Objection to Bowmans Creek Windfarm

I am writing to lodge a formal Objection against the Bowman's Creek Wind Farm (BCWF) near Muswellbrook NSW that is current under development by Epuron.

ENVIRONMENTAL IMPACT STATEMENT REVIEW

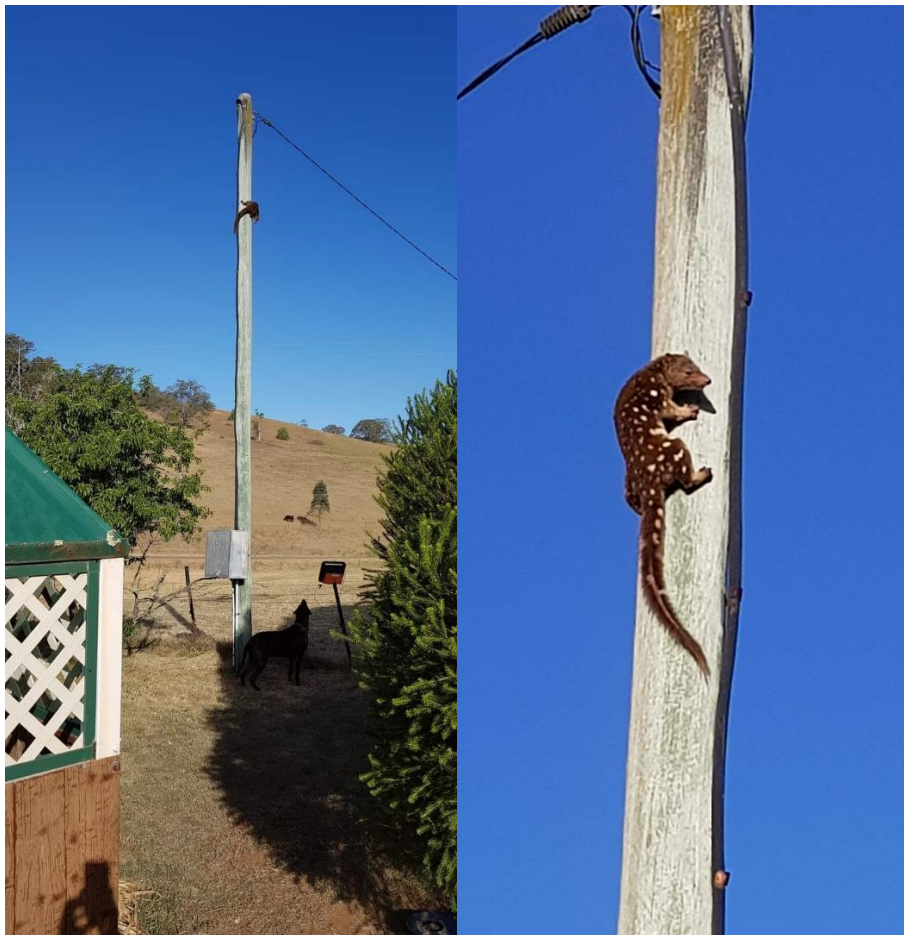
There appears no reference to Grey-headed Flying-fox (threatened) and Little Reddish Flying-fox, I would have considered these species at higher risk of collision and habitat loss.

Nationally important camps are those that have contained $\geq 10,000$ Grey-headed Flying-foxes in more than one year in the last 10 years, or have been occupied by more than 2,500 Grey-headed Flying-foxes permanently or seasonally every year for the last 10 years (DoE 2015). There is one nationally important Grey-headed Flying-foxes located on Muscle Creek near the Hunter River in Muswellbrook. This camp is well within the 50km foraging radius of the turbine layout. There are also another four flying fox camps located within 50km of the

Records from the Mt Owen Mine Fauna Reports clearly show that the Grey Headed Flying Fox are regularly found in the area surrounding the Ravensworth State Forest and Biodiversity offsets. The species has been recorded 10 years of the 25-year according to Mt Owen Mine Species list. The most recent observation was in 2019 were 10+ Grey Headed Flying- Fox at Site MH01 foraging. The Grey-headed Flying-fox was detected foraging on fruiting *Ficus rubiginosa* trees in Mitchell Hills Offset. The Mitchell Hills Biodiversity offset is located on the Project boundary.

The impacts to the Grey headed Flying Fox have been understated in the EIS and the development does not align with the objectives of National Recovery Plan for the Grey-headed Flying-fox. This project will have a landscape impact on protected and threatened species and cannot be dismissed as negligible based on limited data review.

Figure 10 Location of Threatened Fauna recorded, Mitchell Hills BOA.

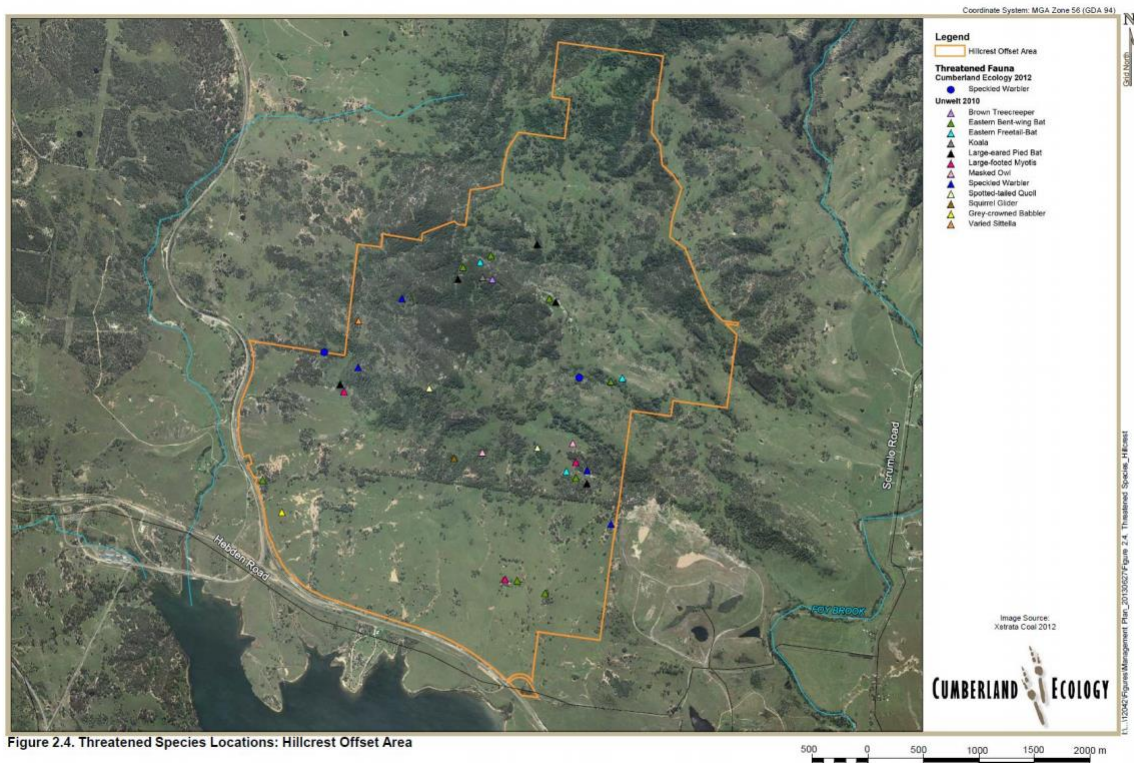
The Little Eagle was observed flying overhead, whilst the Masked Owl was detected by vocalisation response to calls of the species being broadcast at selected sites in Mitchell Hills. The Speckled Warbler is widespread across the offset. Scats of Koala and dieback in the crown of many Forest Red Gum *Eucalyptus tereticornis* trees was observed on the upper slopes of Mitchell Hills BOA during fieldwork. Koala have been observed in the neighbouring Hillcrest BOA by Ravensworth Operations staff and baseline ecological surveys for the offset. The Spotted-tail Quoll was detected by remote camera monitoring in the Dry Rainforest on the eastern side of the BOA.

The locations of threatened fauna recorded at Mitchell Hills BOA is presented below in **Figure 10**.

The dataset collected from Mt Owen and surrounding biodiversity offset areas over the past 23 years, clearly show that a large number of species are missing from the EIS Fauna impact assessment. It appears that this whole dataset has been ignored to downplay the impacts on threatened species at a landscape level.
